RESPONSE TO SUBMISSIONS - ADDENDUM REPORT

Light Horse Interchange
Business Hub (SSD 9667)

Prepared for
WESTERN SYDNEY PARKLANDS TRUST
25 May 2020

Figure 1 - Revised Concept Master Plan (Source: Nettleton Tribe)

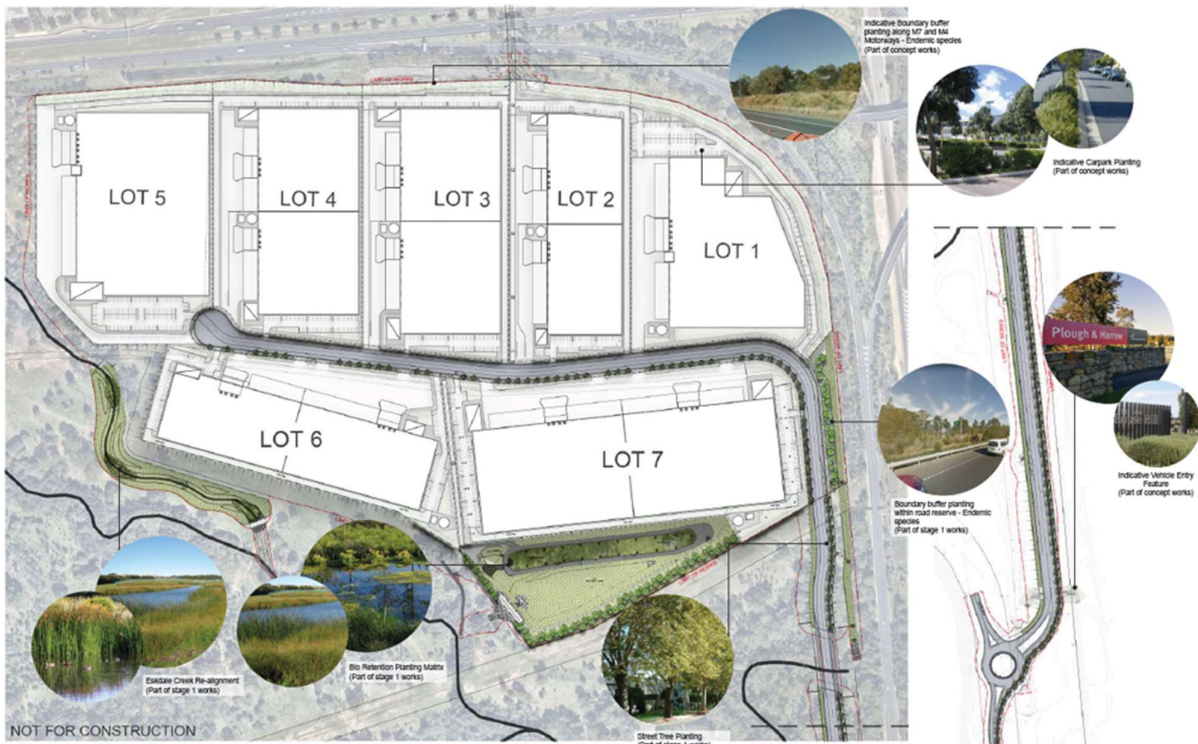
Drawing Number	Drawing Name	Significant Changes
10935_MP100	Concept Masterplan	<ul style="list-style-type: none"> ▪ Indicative landscaping shown on Concept Plan. ▪ Updated linework provided within the bioretention area in Lot 8. ▪ Updated linework provided around the proposed Eskdale Creek re-alignment.

Figure 4 – Biodiversity Corridor Widening Investigation Area (Source: Ecoplanning)

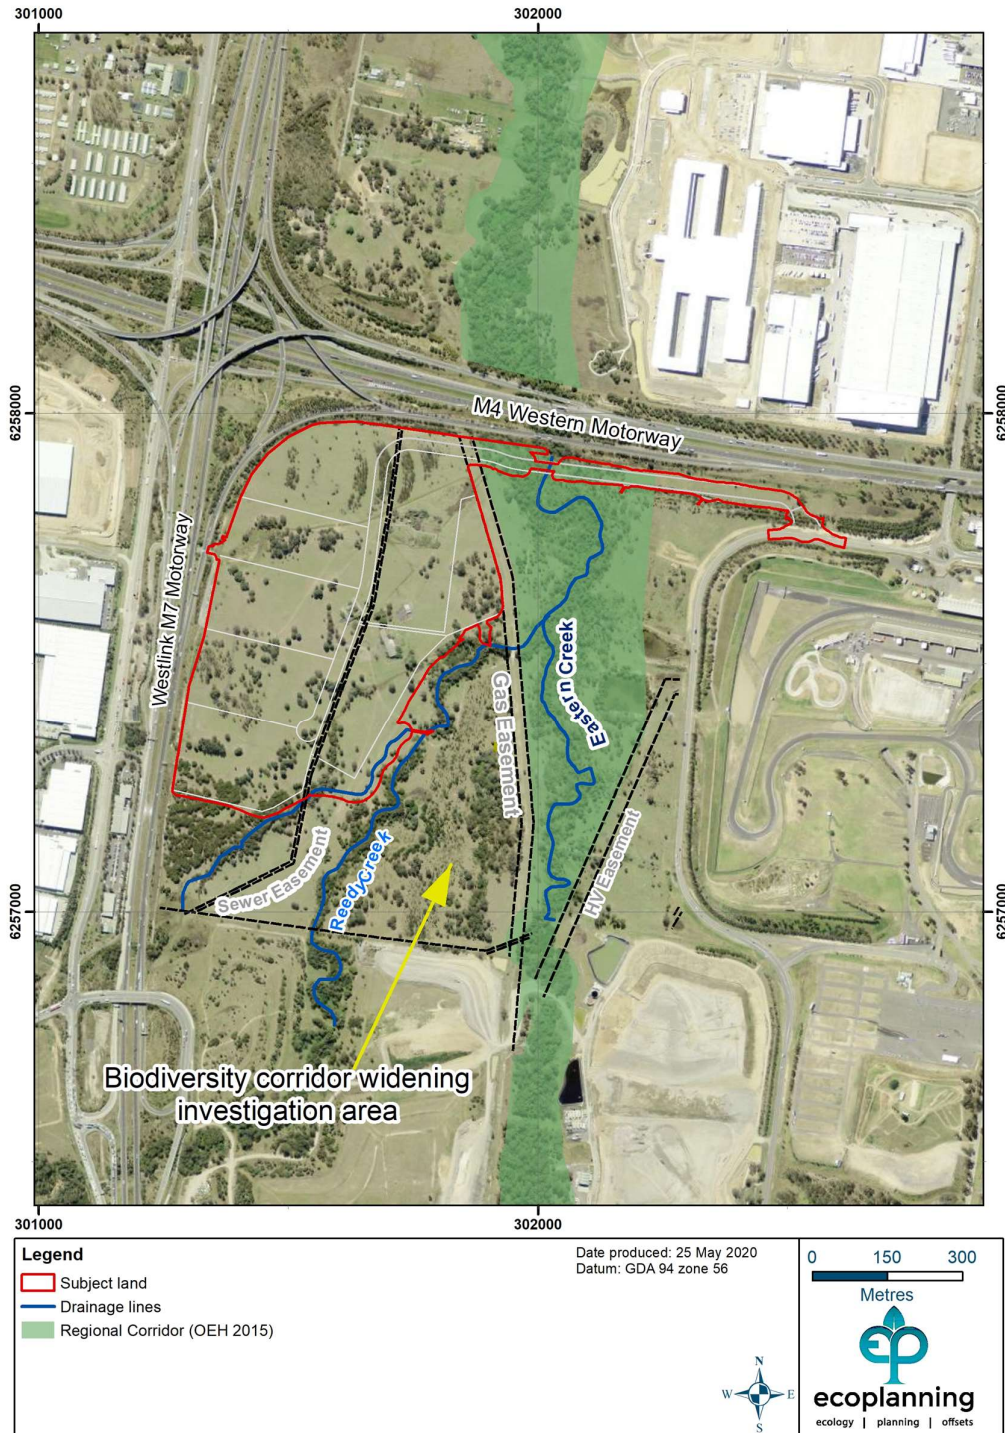
<u>Biodiversity</u>	
<p><u>Bushland Corridor</u></p> <p><i>EES previously recommended the Bushland Corridor be widened along the western side of Eastern Creek within Wallgrove Road Precinct 6 to include part of the site for the reasons outlined in its EIS submission of 6 September 2019.</i></p> <p><i>As previously advised, compared to elsewhere in the Western Sydney Parkland, the Bushland Corridor in Precinct 6 is constrained and reduced in</i></p>	<p>The Bushland Corridor is to be widened in accordance with Strategic Direction 1 Objective 4 of the Parklands Plan of Management 2030.</p> <p>Each of the EES recommendations is responded to as follows:</p> <ul style="list-style-type: none"> ▪ The Bushland Corridor which extends along Eastern Creek is recognised as an important regional corridor and impacts to this corridor have been avoided and minimised wherever

Submission	Response
<p><i>width by development, especially adjacent to Austral Bricks in the southern part of Precinct 6 and in the vicinity of the Western Sydney International Dragway. EES recommended the corridor be widened to improve its robustness, especially with increasing visitor numbers using the parkland for recreational purposes.</i></p> <p><i>The proposed development will remove the potential to widen the Bushland Corridor along this section of creek as it will remove/narrow the existing open vacant grassland and native vegetation at the site.</i></p> <p><i>The RTS has not addressed the issues raised by EES in relation to the Bushland Corridor. EES repeats its recommendations, namely:</i></p> <ul style="list-style-type: none"> ▪ <i>the Bushland Corridor is widened along the western side of Eastern Creek to include part of the site</i> ▪ <i>native vegetation within Lots 6, 7 and 8 is included in the Bushland Corridor and the Concept Masterplan is amended to include Lot 8 (i.e. where the bio-retention basin is proposed) in the Bushland Corridor and Lots 6 and 7 are reconfigured to retain intact Alluvial Woodland and under-scrubbed Alluvial Woodland which is contiguous with the remnant vegetation located to the south of the site</i> ▪ <i>the bio-retention basin is located closer to the proposed Lots 1-5.</i> 	<p>possible. WSPT proposes to widen the existing bushland corridor on the western side of Eastern Creek at the southern portion adjacent to the landfill site (refer Figure 4). This is the narrowest part of the current Bushland Corridor where it is pinched by the Jemena gas easement and the electrical transmission line. Widening at this location will provide the greatest expansion to the west as it creates a connection to the Melaleuca forest that was avoided in the early redesign of the development footprint. It will assist with a more regional connection via Reedy Creek and Erskine Creek with potential connectivity further west to the South Creek corridor. It also has future potential to incorporate the rehabilitation of the landfill site in the long-term to create a larger home range for core habitat.</p> <ul style="list-style-type: none"> ▪ While WSPT agrees the Bushland Corridor should be widened (as detailed above), WSPT does not propose amending the project footprint for Lots 6, 7 and 8. It is proposed to widen the Bushland Corridor on the western side of Eastern Creek to include areas between Reedy Creek and Eastern Creek, as mentioned above (see Figure 4). Widening the Bushland Corridor in the northern portion of the site (Lots 6, 7 and 8) is not proposed as a contiguous bushland corridor extending west from Eastern Creek is not possible due to the presence of the existing Jemena Gas easement. Additionally, the future potential of a widened bushland corridor immediately adjacent to the M4 Western Motorway would be limited in comparison to areas to the south which have potential for future southern expansions. ▪ The location of the bio-retention basin is justified in detail within the letter from Henry & Hymas Engineers (Appendix K) and within Section 4.2 of this report. Significant investigations were undertaken to ensure the layout addresses the site characteristics and incorporates principles of sustainable engineering. The proposed location of the bio-retention basin has been primarily driven by the flooding and stormwater requirements. The

Submission	Response
	<p>detailed civil engineering matters are summarised in the following points:</p> <ul style="list-style-type: none"> – Constraints of existing high-pressure gas easement. – Alignment to existing sewer easement (noting buildings cannot be built over easement). – Minimisation of disturbance to the natural environment. – Minimise impacts on flooding within the Eastern Creek Floodplain. – Provide emergency access circulation and align to existing and proposed access point. – Circulation of large vehicles servicing the development. – Provide continuation of existing overland flow paths and internally manage and reduce number of overland flows. – Provide lot layouts and road network that drain to a single communal stormwater management basin. <p>Stormwater quantity and quality is to be managed in a single communal basin to:</p> <ul style="list-style-type: none"> – Minimise number of outlets and ecological impact to surrounding natural watercourses. – Minimise number of crossings of existing sewer easements. – Prevent crossing of the existing high-pressure gas main. – Improved economies of scale, with a single large bioretention basin and detention basin. – Single point of maintenance and minimise maintenance paths and infrastructure. – Minimise number of basin overland flow paths traversing the proposed development. <p>It is considered that the subdivision layout, including the bio-retention basin, is appropriate and represents an optimal outcome for the site. The proposed development seeks to utilise land which has low conservation or recreation value</p>

Submission	Response
	in accordance with the adopted POM for the Western Sydney Parklands. The proposed subdivision layout responds to the natural and built environment characteristics and will comply with relevant engineering requirements.
